PCN Title: Change GBPC (W) Package Outline Dimensions for Select

PRODUCT CHANGE NOTICE

PCN-2597 REV1

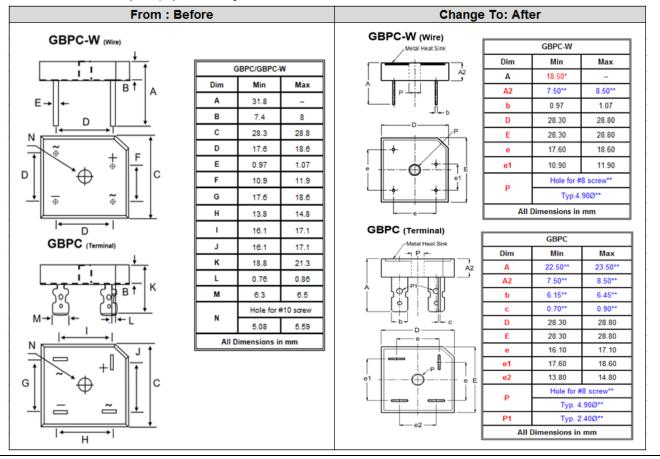
This PCN is being issued to notify customers that in order to improve assembly manufacturability, Diodes Incorporated has qualified the change of package height for the GBPC-W package as outlined below, see (*).

In addition, some package outline dimensions (PODs) have been corrected in the POD tables for GBPC-W, and GBPC as shown below, see (**); no physical changes are being made.

Notes: "*" Actual change in physical dimension for GBPC-W package.

"**" POD correction only, no physical change.
